# ADDENDUM NO. 06

**October 6, 2023**

**Northwestern School Corporation – Multiple Projects**  
**3431 County Rd N 400 W**  
**Kokomo, IN 46901**

PREPARED BY SCHMIDT ASSOCIATES FOR:  
**NORTHWESTERN TIGERS BUILDING UPDATES**  
**NORTHWESTERN (HOWARD) SCHOOL CORPORATION**

2-AC1G1

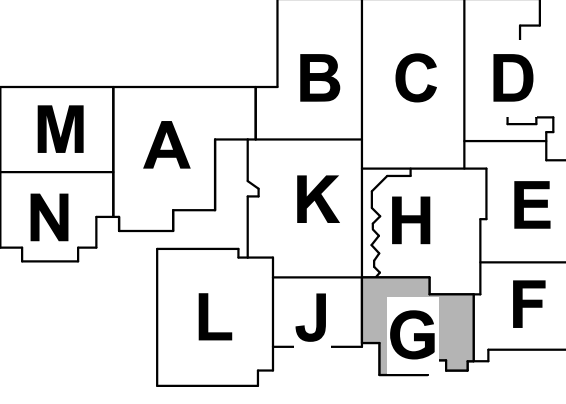
DRAWING NO.	INDICATE ACTION: ADD (A), DELETE (D), DELETE & REPLACE (R),
<b>A-SERIES DRAWINGS</b>	
2-AC1G1	DELETE AND REPLACE
